March 15, 2023

Re: Bike Lane Design in Connecticut Avenue Deckover and Streetscape Project

Figure 1 - DDOT Proposed Cross Section with 5' bike lanes

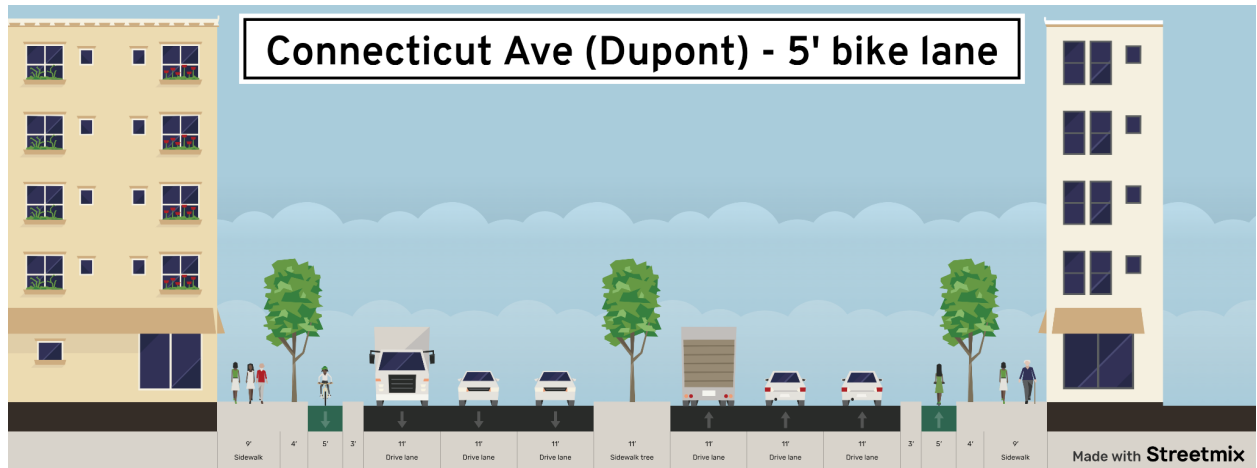
On behalf of the Washington Area Bicyclist Association, and its 6,000 members in the Washington Region, I am writing to repeat and emphasize an important concern in the Connecticut Avenue Streetscape and Deckover project's bike lane design that has not been addressed by the project team. At just 5 feet wide, the proposed protected bike lanes are too narrow for the context and expected user volume and will limit the usability of this link in the priority bicycle network. We believe that there is a straightforward solution; narrow some driving lanes from 11' to 10' and repurpose the road width to allow 7' bike lanes. This should not impact the project schedule or cost, but improve traffic safety and better future-proof the road's multimodal design.

We do not find these reasons convincing and believe that DDOT's Design and Engineering Manual (DEM) and federal guidance better supports wider (7') bike lanes and narrower (10') driving lanes here. We urge DDOT to make a modest design change. Reduce the width of two driving lanes in each direction from 11' to 10' and push the bike lane curbs 2' closer to the center line (see Figure 1 and 2 for illustration). This change allows for the recommended 7' bike lanes while maintaining an 11' outside lane for buses. 10' driving lanes are supported by the DDOT DEM and ubiquitous on multi-lane roads in DC, including on Connecticut Avenue. Research shows that narrower lanes lead to more careful driving, slower speeds, and fewer crashes. This change would not modify the planned curb line and should not impact drainage so is unlikely to increase cost or add delay.

Every protected bike lane standard and design guide published in the last 10 years, including DDOT's own, agrees that a 5' wide bike lane between raised curbs is the minimum acceptable width and not recommended for high-volume corridors or on hills. Compared to a 6.5' - 7' protected bike lane, 5' bike lanes:

Figure 2 - WABA Proposed Cross Section with 7' bike lanes
